March 15, 2018)

**Cheryl Moon Siriani, District Executive  
Penn DOT, District #11, Thoms Run Road  
Bridgeville, Pa. 15017**

**To Cheryl Moon Siriani :**

## **THE FOLLOWING FACTS SEEM TO SUGGEST A RE- CONSIDERATION OF CONSTRUCTING THE LEFT TURN STACKING LANE**

# The SOLUTION :

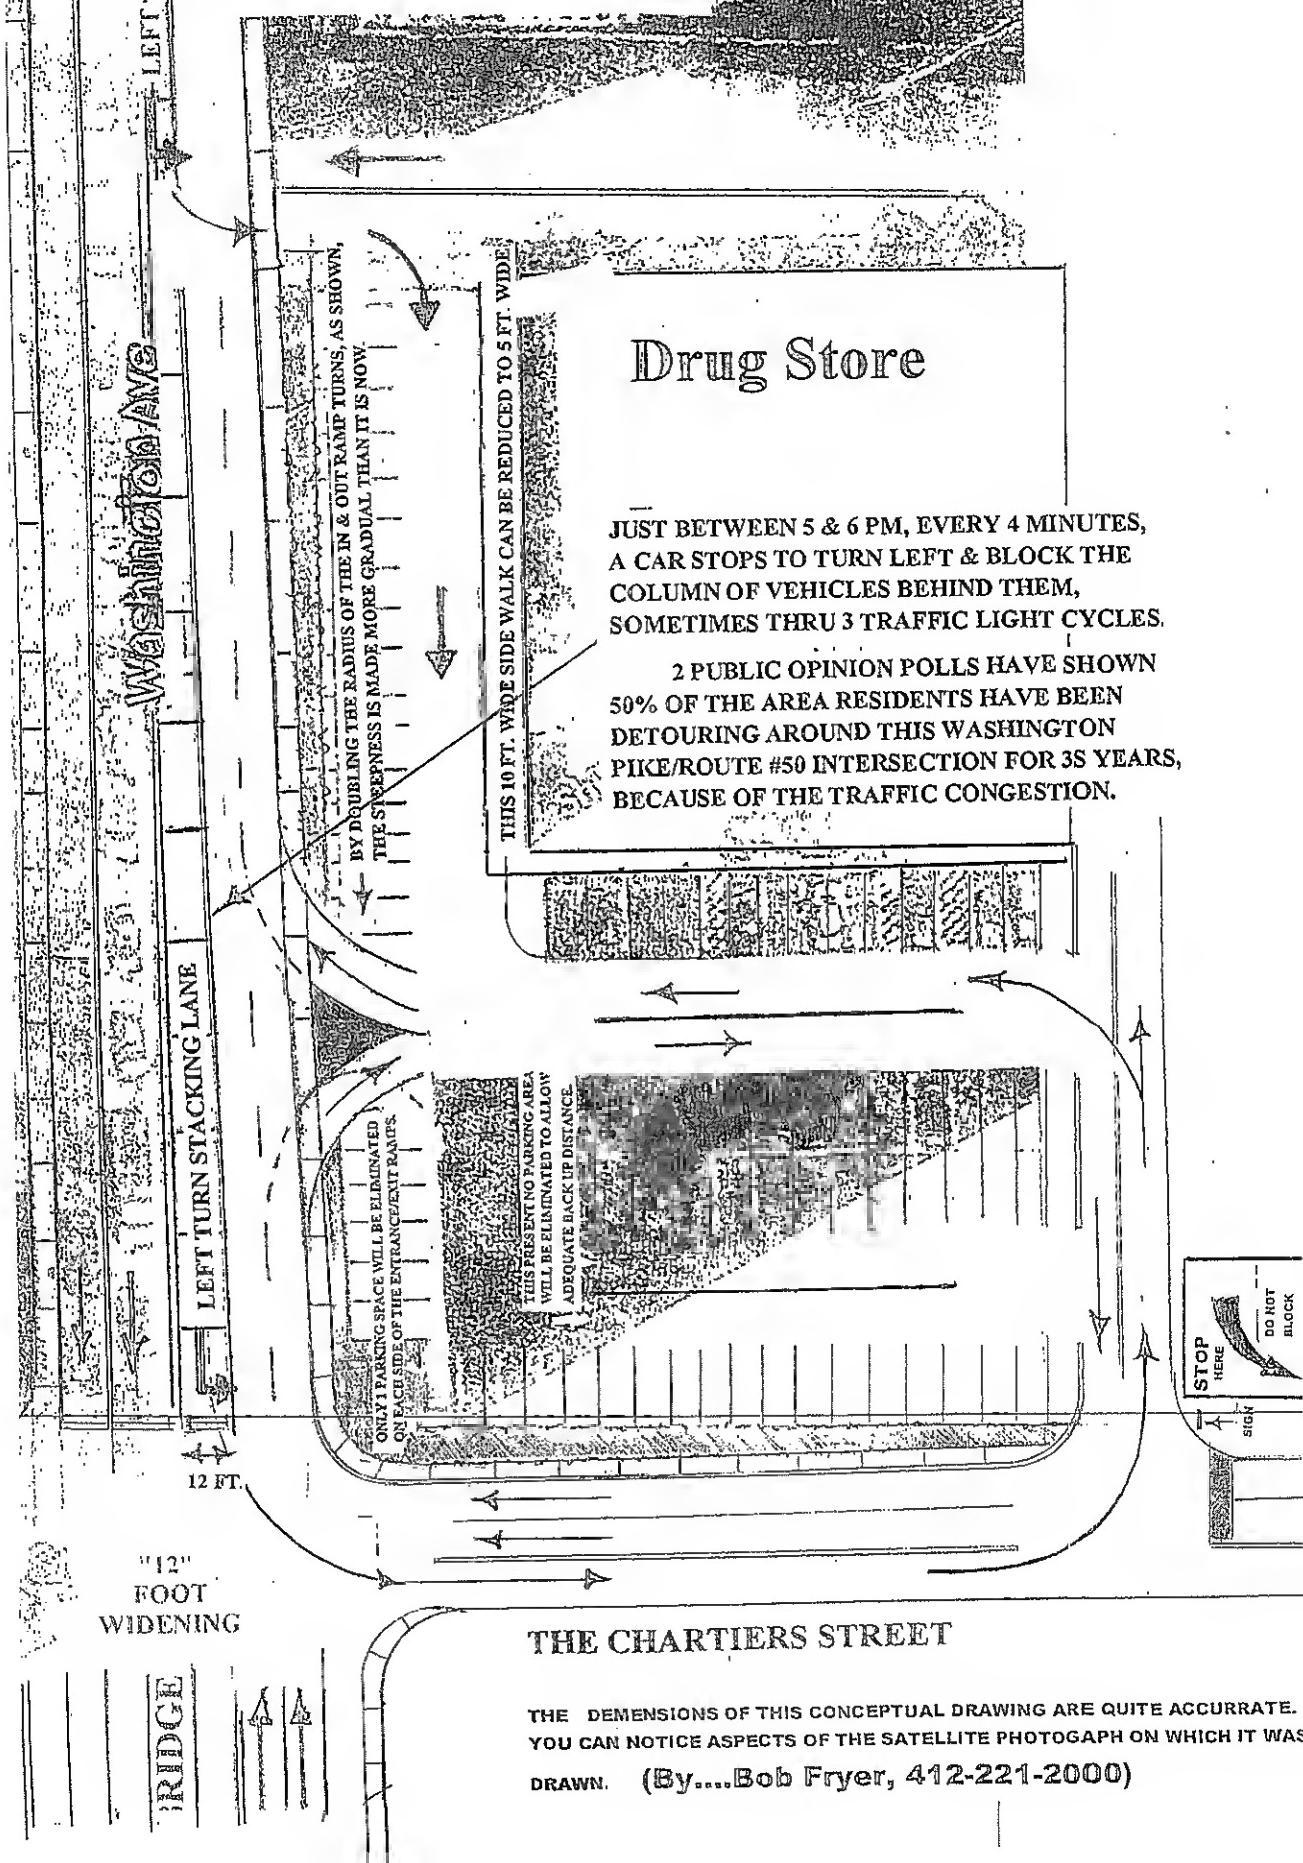
We defined the "new necessary position" of the inside edge of the new Washington Avenue sidewalk closest to the store as... a "tapered" straight line, from its widest 10 FOOT width closest to the Chartiers Street corner, decreasing to "0" FEET in width as it continued 450 feet further North, to the corner of James Street, across from the U.S. Post Office.

Therefore, the amount of property needed becomes less and less as the new sidewalk continues to the North. SEE DRAWING.

SHOWN BELOW IS THE PROPOSED NEW POSITION OF THE INSIDE EDGE OF THE WASHINGTON AVENUE SIDEWALK, THAT IS NECESSARY FOR THE "LEFT TURN STACKING LANE" TO BE BUILT.

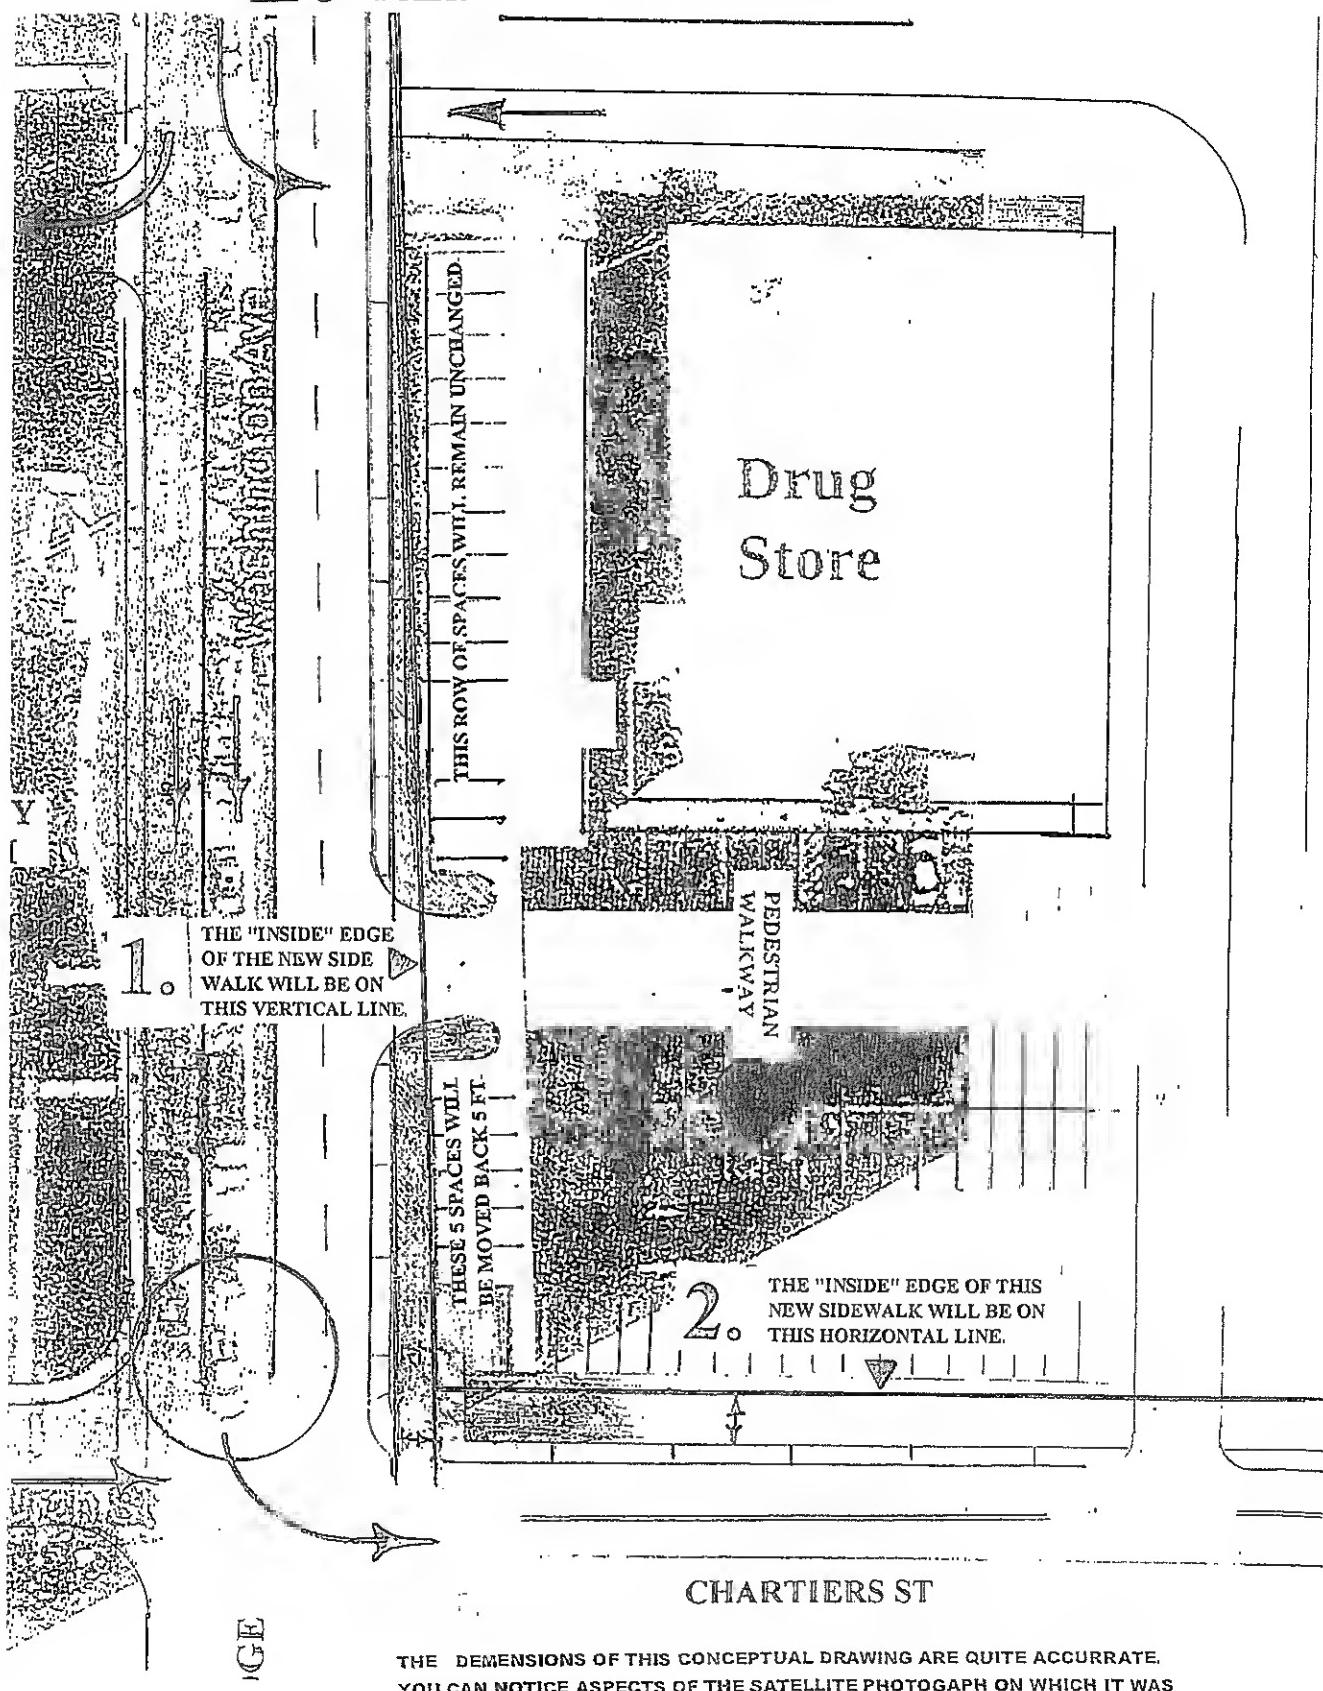
SHOWN BELOW IS THE PROPOSED NEW POSITION OF THE INSIDE EDGE OF THE CHARTIERS STREET SIDEWALK, THAT IS NECESSARY FOR THE "ADDITIONAL" STACKING LANE TO BE BUILT.

THE GATEWAY TO BRIDGEVILLE'S  
CENTRAL BUSINESS DISTRICT

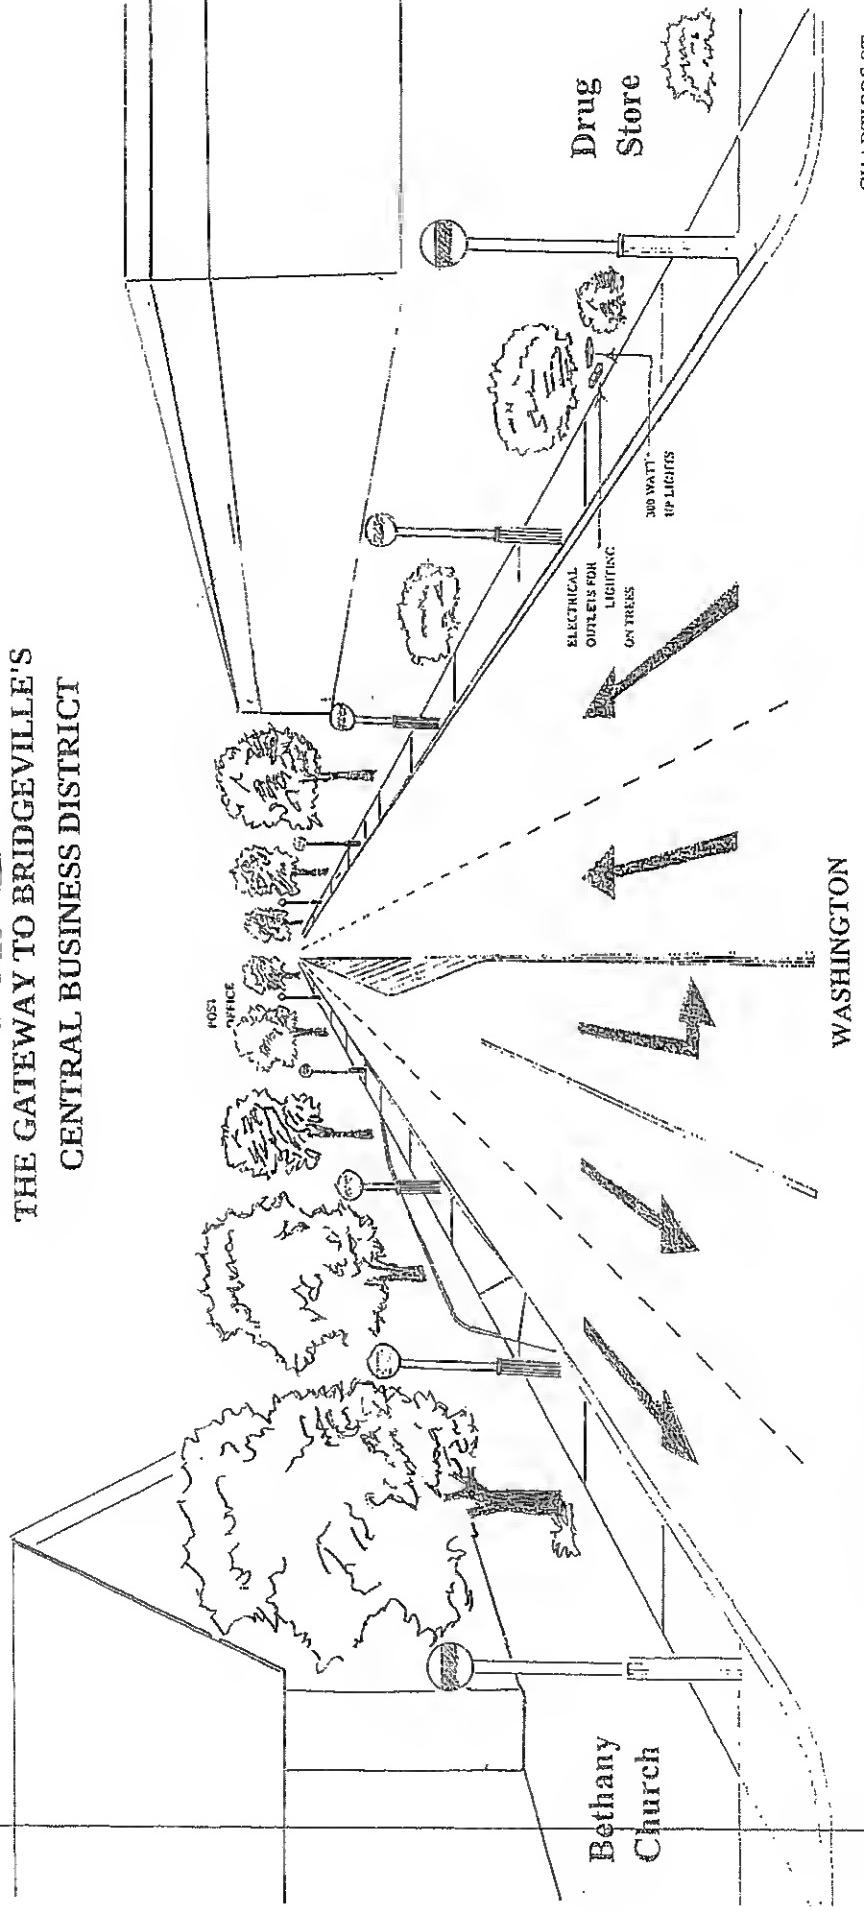
STREET TREE PLAN"  
WOULD GIVE BRIDGEVILLE...  
THE MOST BEAUTIFUL MAIN STREET  
OF ANY COMMUNITY IN THE  
REGION, AND CREATE A LOOK THAT  
WOULD ATTRACT NEW TAX  
REVENUE PRODUCING BUSINESSES  
TO ITS BUSINESS DISTRICTS.

THIS STREET TREE PLAN  
WOULD REQUIRE THE APPROVAL  
OF THE U.S. POST OFFICE, THE  
BETHANY CHURCH, THE DRUG  
STORE, THE OWNERS OF 3  
COMMERCIAL BUILDINGS and A  
HOME OWNER.

Only low level landscaping and flowering shrubs, so as to not  
excessively obstruct view of Rite-Aid store.  
(By....Bob Fryer, 412-221-2000)
